WILSON
FINAL
ENVIRONMENTAL ASSESSMENT AND
COASTAL ENGINEERING EVALUATION FOR
SHORELINE SETBACK VARIANCE APPLICATION

TMK: 5-5-02:92 (Ronald N. Lee)
TMK: 5-5-02:93 (Bernard J. Wilson)
Laie, Oahu, Hawaii

**Draft Environmental Assessment
Review Comments and Response Letters**

FIGURE 3-3. AERIAL PHOTOGRAPH OF PROJECT VICINITY (MAY 2000)

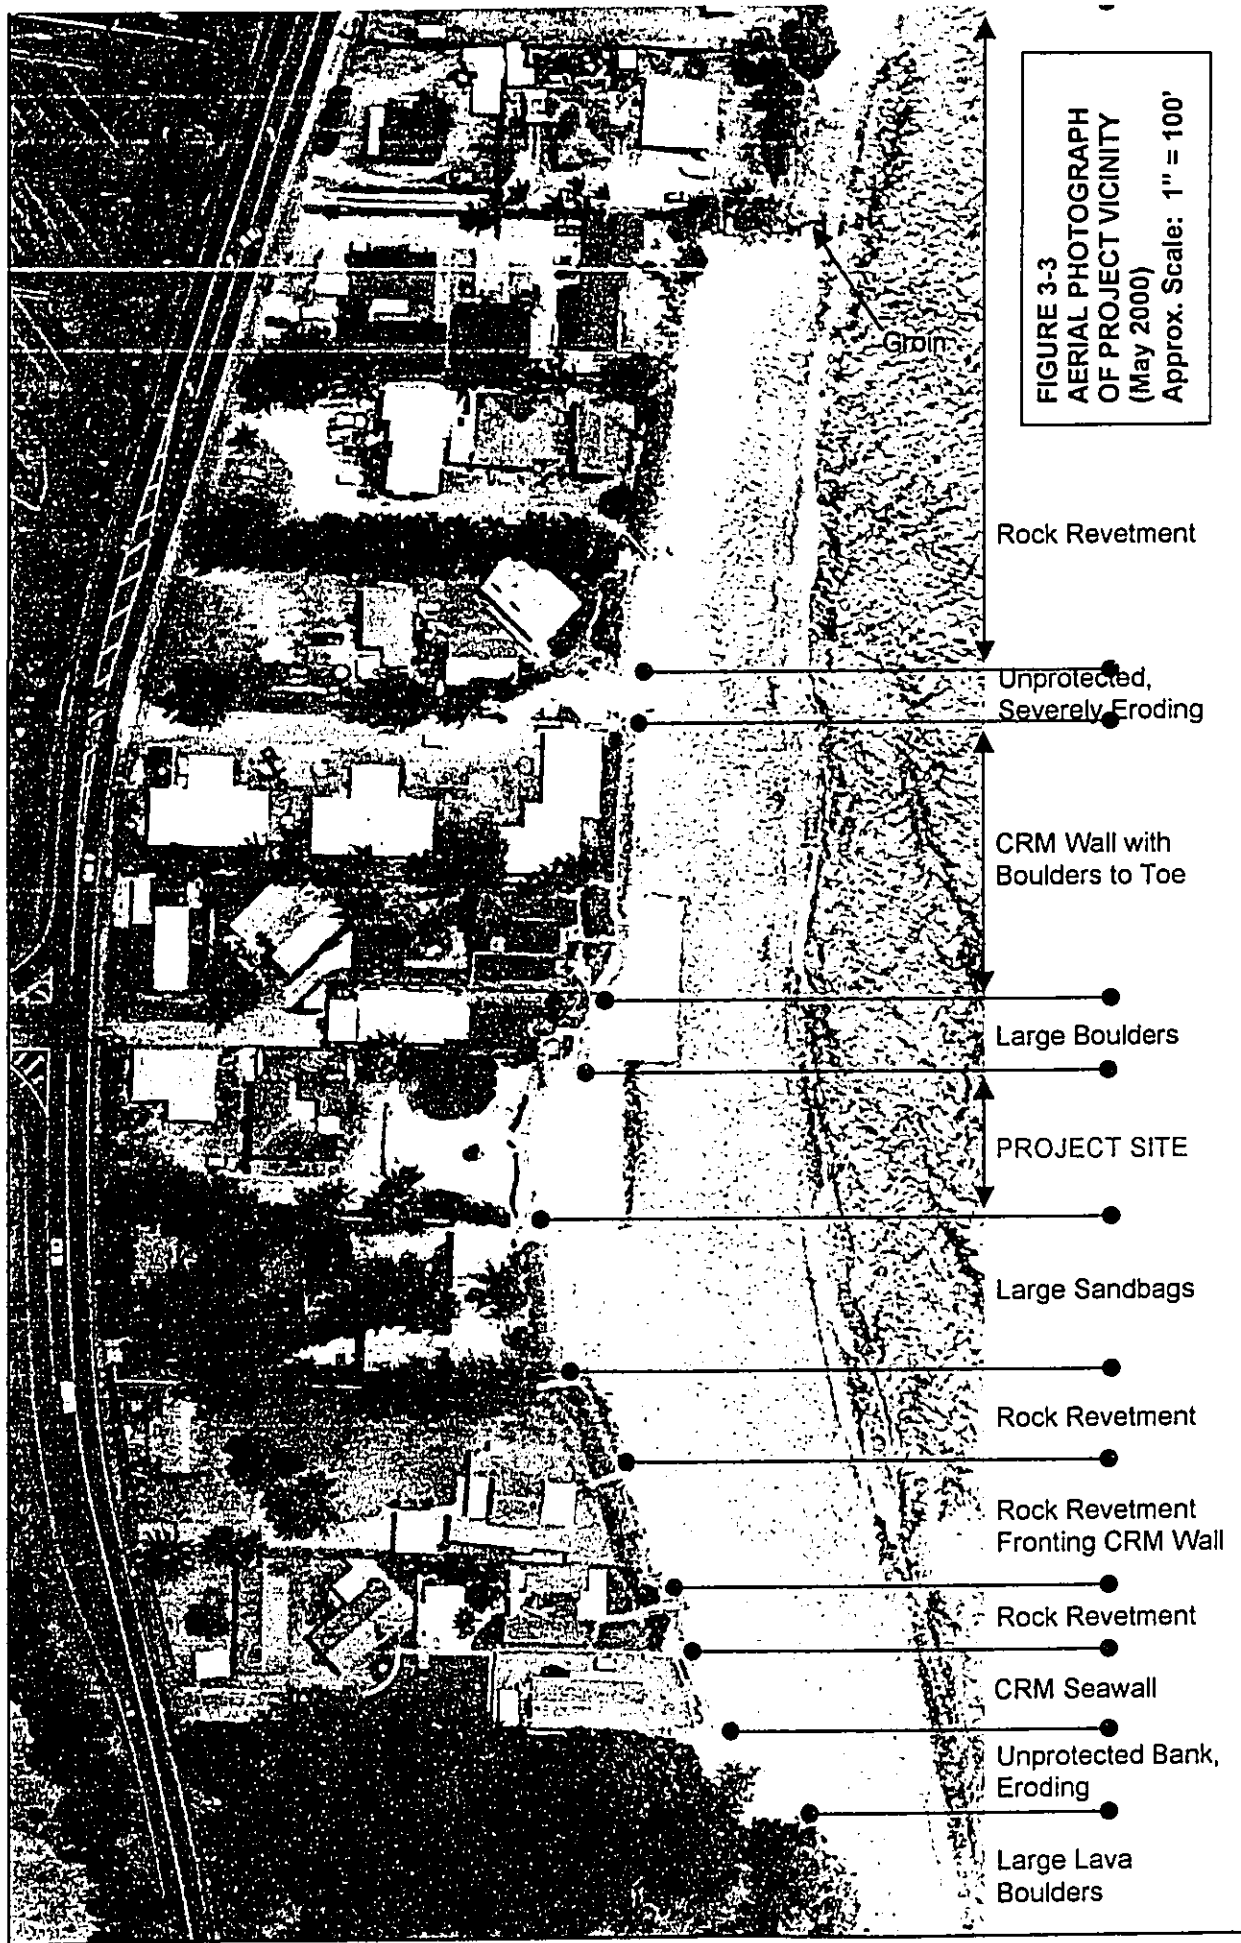
The OCCL suggests that the existing rock pile and crib wall in the inter tidal shoreline fronting the subject property be removed. These structures are both easily identifiable in Figure 3-3 of the Draft EA as are clearly within State lands. The rock pile and old crib wall to the immediate north appear to offer no significant shore protection. It is possible these unauthorized structure may actually be accelerating the erosion in this area by increasing the long shore transport rate of sediment. It may be possible to use the basalt boulders from the rock pile fronting the project site as material for the proposed revetment. This would provide a cost savings to the applicant as well as remove a derelict shoreline structure from State land.
